Re: ZC Case 06-03 -- 100 M Street, S.E.: Request for Minor Modification of Plans the Zoning Commission Previously Reviewed and Approved under Provisions of the Capitol Gateway Overlay

**100 M STREET S.E.**  
**WASHINGTON, DC**  
**OFFICE BUILDING**  
**REQUEST FOR MODIFICATIONS - ZONING**

INDEX	BOARD OF ZONING REQUEST FOR MODIFICATION SET (02/28/07)
COVER	INDEX
L-1	ORIGINAL LANDSCAPE PLAN RENDERING
L-1R	REVISED LANDSCAPE PLAN RENDERING
A-3	ORIGINAL FIRST AND SECOND FLOOR PLAN
A-3R	REVISED FIRST FLOOR PLAN
A-6	ORIGINAL PENTHOUSE - ROOF PLAN
A-6R	REVISED PENTHOUSE - ROOF PLAN
A-11	ORIGINAL EAST ELEVATION
A-11R	REVISED EAST ELEVATION
A-12	ORIGINAL WEST ELEVATION
A-12R	REVISED WEST ELEVATION

FIRST FLOOR PLAN

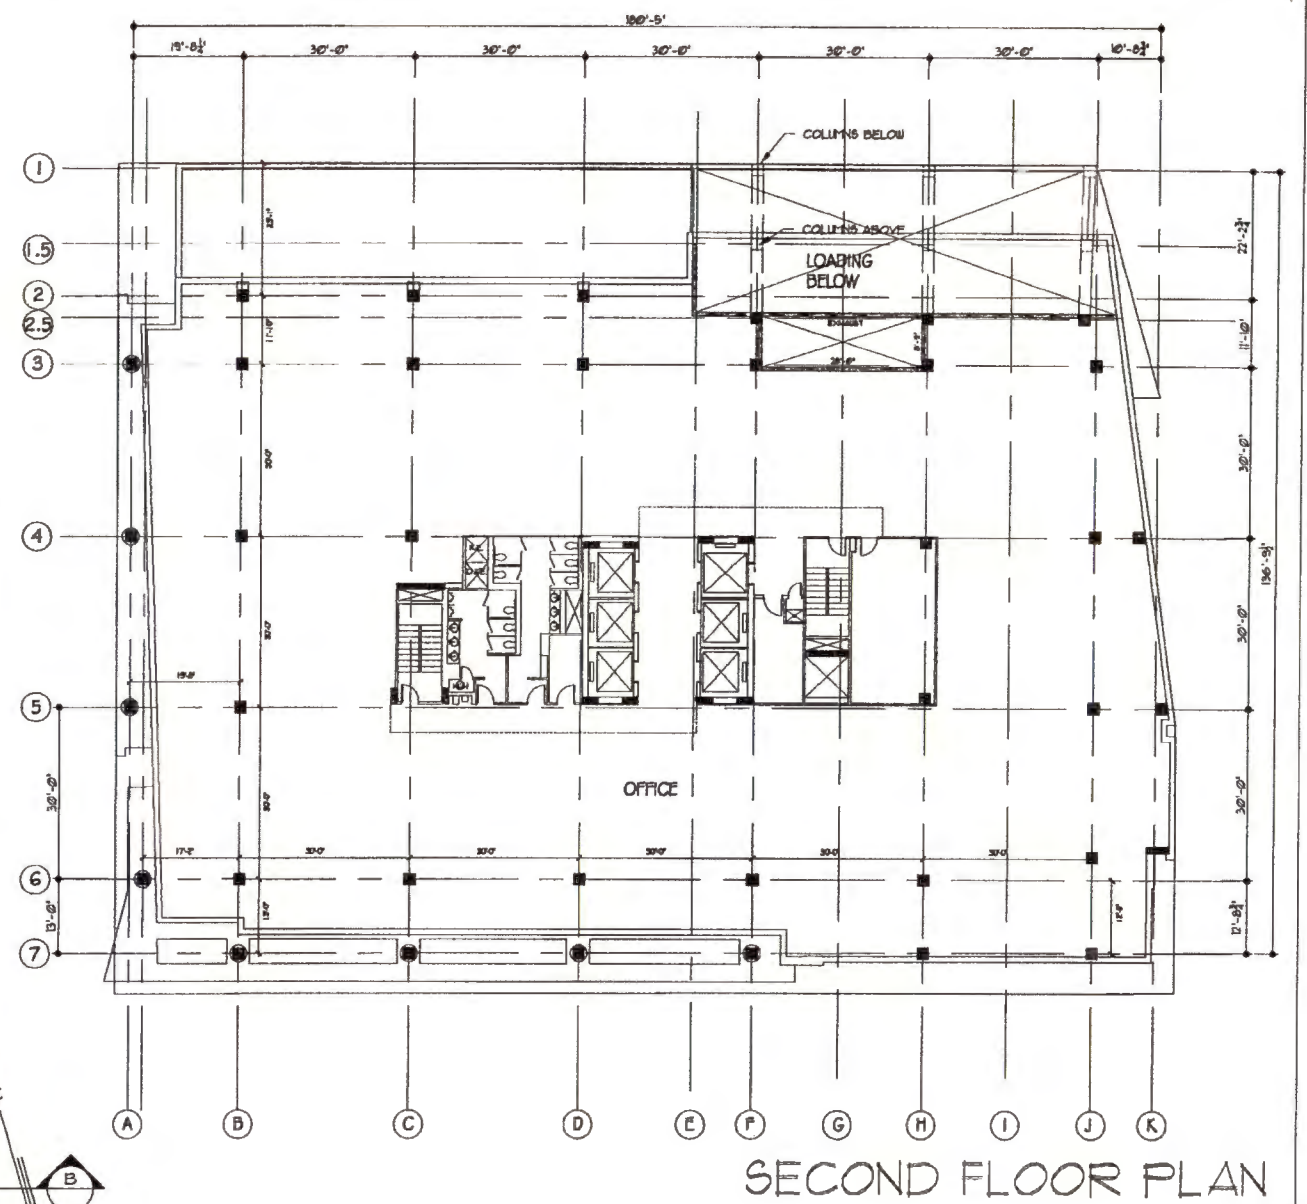
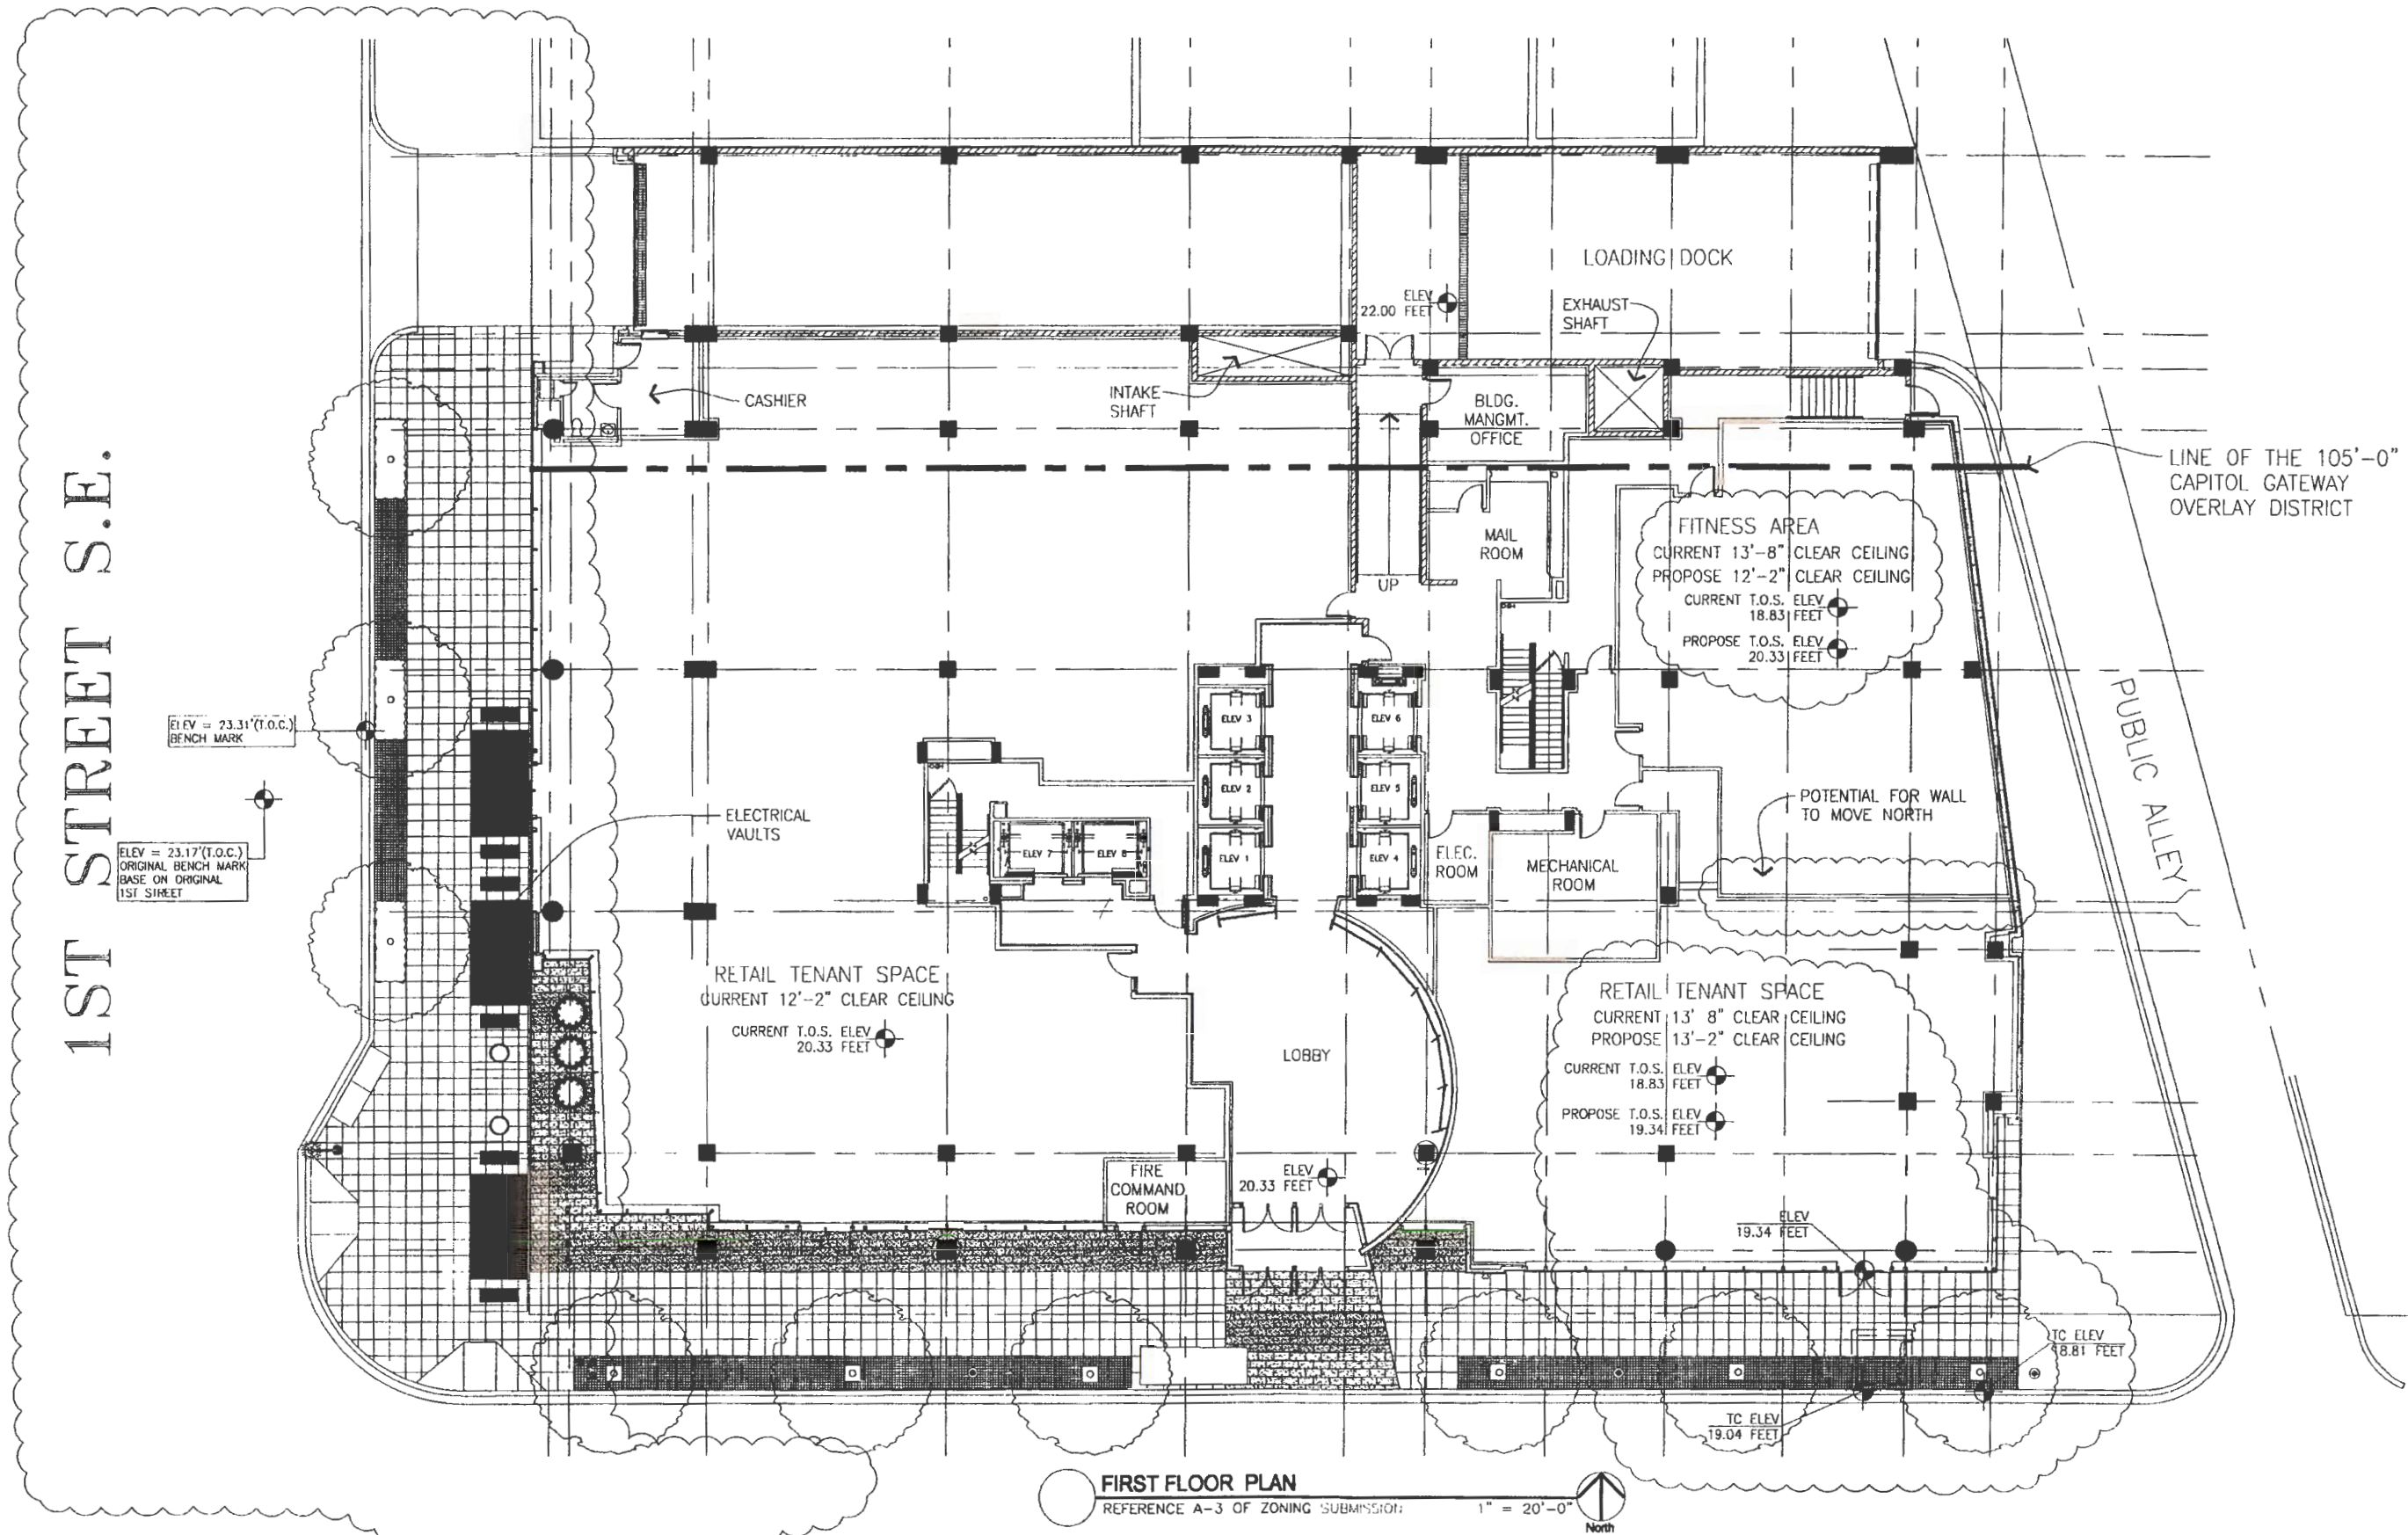
**2. Modifications Sought for Eastern Retail Area and Establishing a Fitness Room:**

The original plans for the eastern retail area called for a "clear ceiling" height of 13' 8" that was approved for the full depth of that retail area. However, that clear height is achieved only by having an undesirable six inch (6") step down to that level from the plane of the entrance. The owner feels such a step is less desirable to a successful M Street experience than maintaining the stated and approved "clear ceiling" height of that space.

- Reduce the depth of the eastern retail area to at least 45 feet from the southern face of the building.
- Establish a fitness area as an accessory use in the windowless area between the rear portion of the eastern retail area (as depicted in the plans initially reviewed and approved) and the loading dock. As an accessory use, the finished plane of this floor area would be raised to be the same as that of the lobby and other areas of the main building, thereby resolving access requirements to all such areas by persons with mobility limitations.

- Raise the plane of the floor of this retail area from the benchmark of 18.83 feet by half a foot (0.5 ft.) to 19.34 feet, matching the finished grade of the sidewalk and the paved five-foot setback area along M Street. Raising the floor would have the consequence of reducing the clear height of the ceiling from thirteen feet eight inches (13' 8") to ***at least*** thirteen feet two inches (13' 2"). As a percentage of the fourteen foot (14' 0") requirement that became effective February 16, 2007, the clear height of this ceiling as approved represented 97.6 percent of the height standard being considered as a text amendment when the project was reviewed and approved on May 25, 2006; the "clear height" is still over 95 percent (95.2 %) of the height now normally required under terms of the just-adopted regulation.

PENTHOUSE

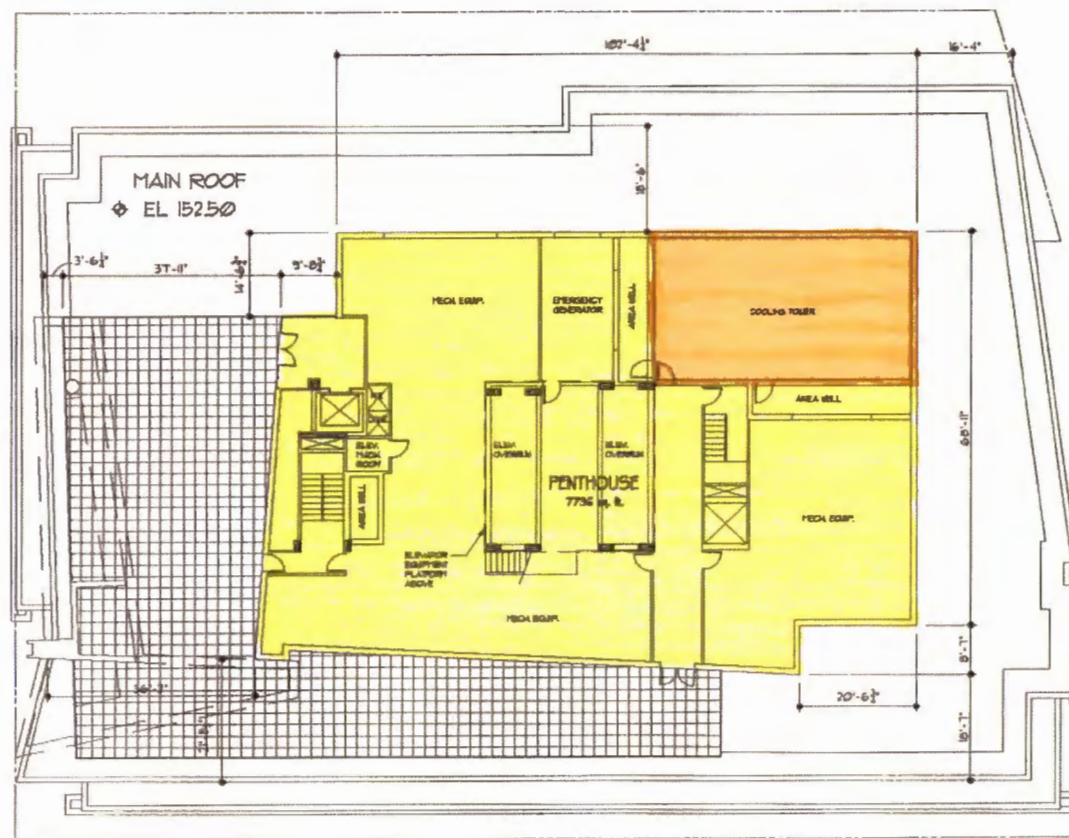
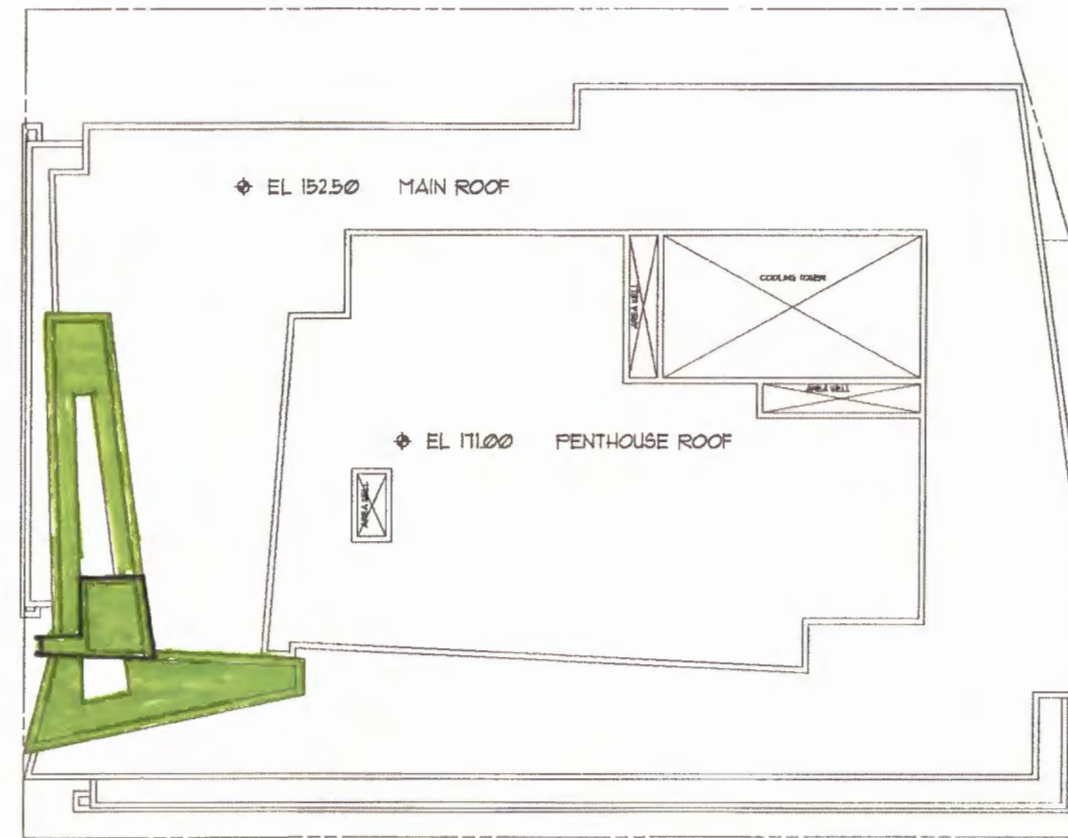
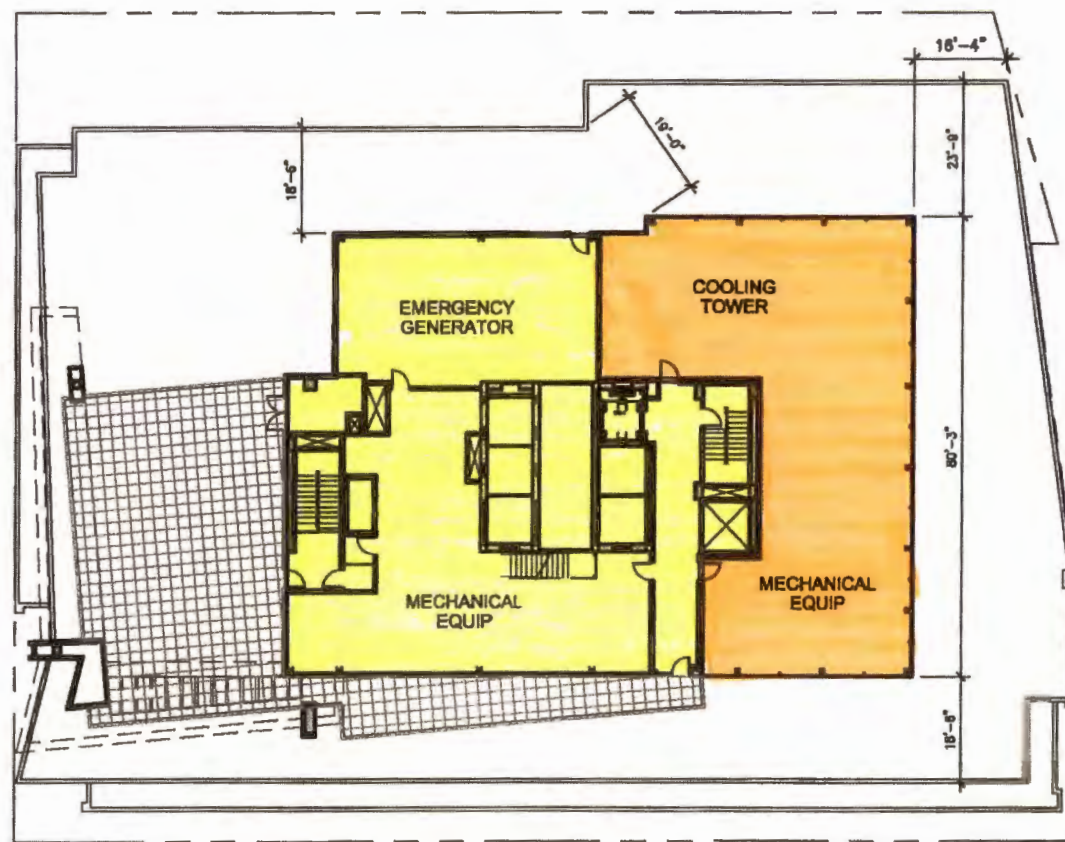
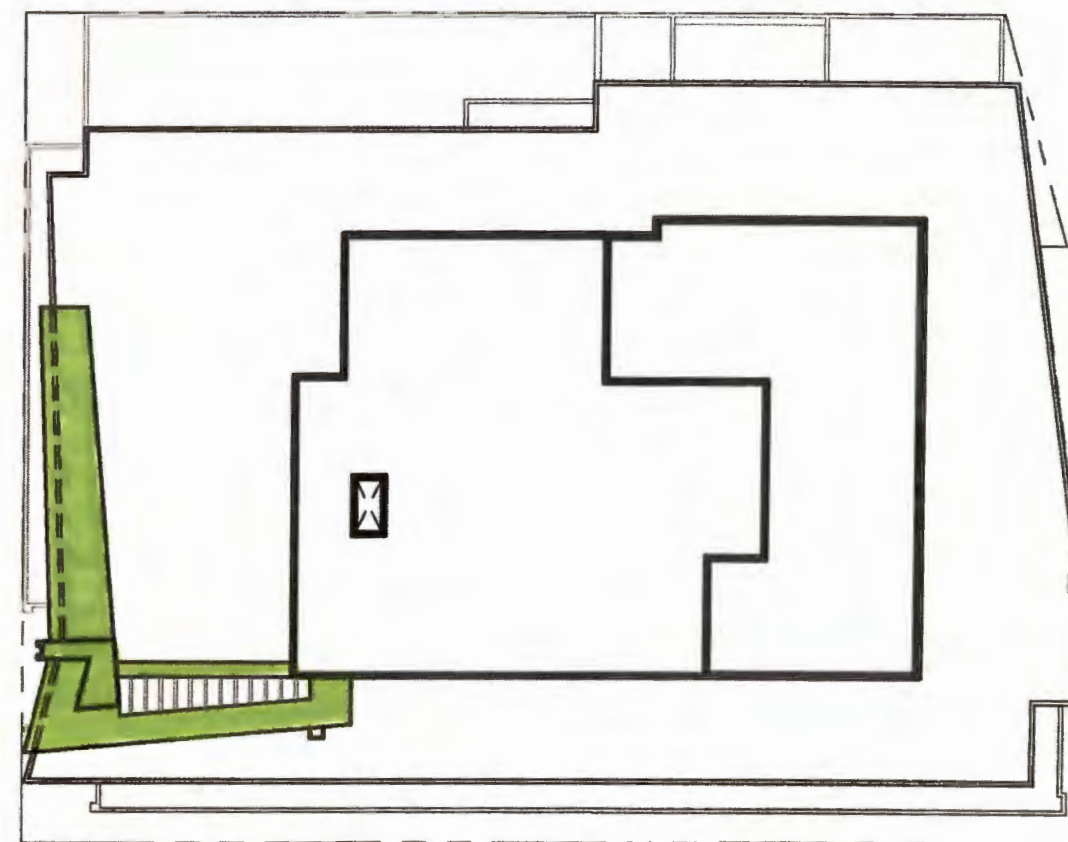
### **Refinements to the Embellishment at the Rooftop at the Southwestern Corner of the Building**

Study of the rooftop embellishment after the hearing of May 25, 2006 has resulted in a **reduction** in its total area (reducing its overall “footprint” of about 1,400 square feet to 1,300 square feet). In addition, the embellishment is now somewhat more “open” than was suggested in the diagrams included in the materials reviewed and approved at the hearing May 25, 2006.. Finally, the structural elements needed to support the embellishment are located where they can carry the load safely with minimal bulk. In particular, the original support system initially located just **north** of the vertical element of the First Street façade is been relocated just **south** of that vertical design element. At the same time, the volume of the support structure is reduced. While this support structure appears in both the original and proposed western elevations, it does not appear in the original eastern elevation as it was totally obscured by the overall rooftop penthouse. In the eastern elevation showing minor modifications to address the glazing code issue, the support structure is depicted, but with faint lines as it is at the far western end of the building; it is not attached to the penthouse itself. The enclosed comparative roof diagrams add further clarification.
